Sundry Print Report

Well Name: Fuller 14/11 W1GB Fed Com	Well Location: T26S / R29E / SEC 14 / SWNE /	County or Parish/State:
Well Number: 2H	Type of Well: CONVENTIONAL GAS WELL	Allottee or Tribe Name:
Lease Number: NMNM11038	Unit or CA Name: FULLER W1HA W2HA 2H 3H	Unit or CA Number: NMNM138709
US Well Number: 3001549328	Well Status: Approved Application for Permit to Drill	Operator: MEWBOURNE OIL COMPANY

Type of Submission: Notice of Intent

Procedure Description: Mewbourne Oil Company requests that the following changes be made to Fuller 14/11 W1GB Fed Com #2H well: 1. Well name change to Fuller 14/23 W1JO Fed #1H. 2. BHL change to 330' FSL & 2230' FEL in Sec 23, T26S, R29E 3. Changes to directional design plot & plan corresponding to BHL change are included in sundry attachments. 4. Changes to csg program & cmt program corresponding to BHL change are included in this sundry request on page 3 & 4.

WELL LOCATION AND ACREAGE DEDICATION PLAT

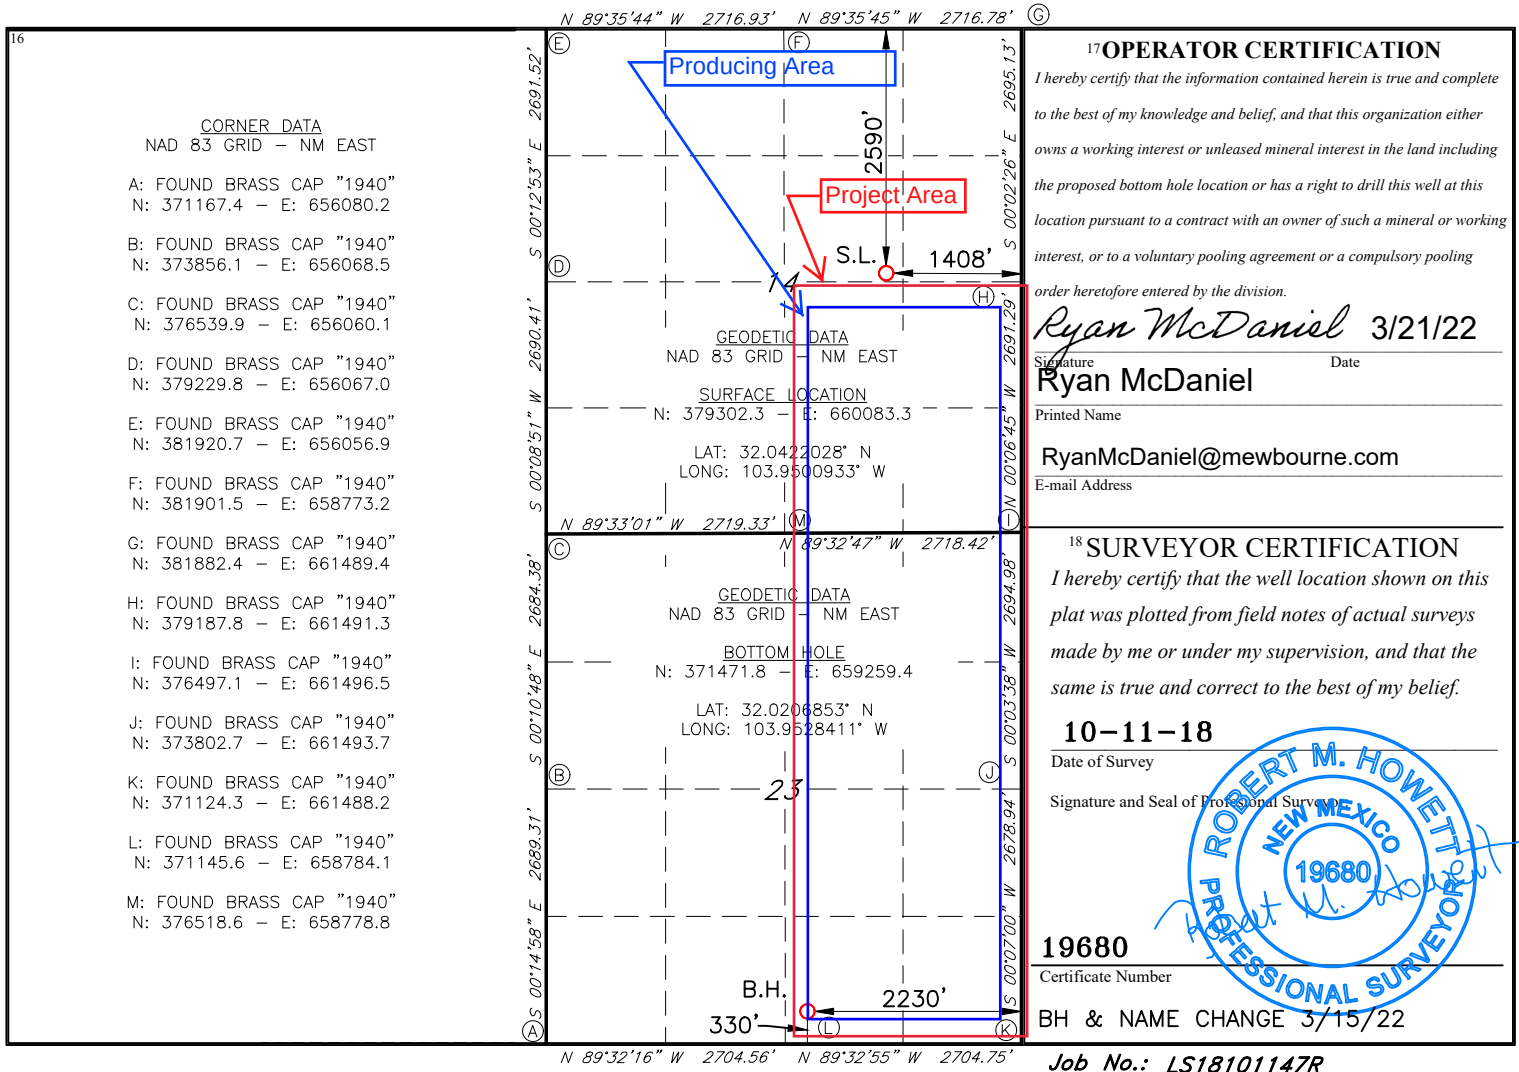
1. Well name change to Fuller 14/23 W1JO Fed #1H.
2. BHL change to 330' FSL & 2230' FEL in Sec 23, T26S, R29E
3. Changes to directional design plot & plan corresponding to BHL change are included in sundry attachments.
4. Changes to csg program & cmt program corresponding to BHL change are included in this sundry request on page 3 & 4.

UL or lot no.	Section	Township	Range	Lot Idn	Feet from the	North/South line	Feet from the	East/West line	County
0	23	26S	29E		330	SOUTH	2230	EAST	EDDY
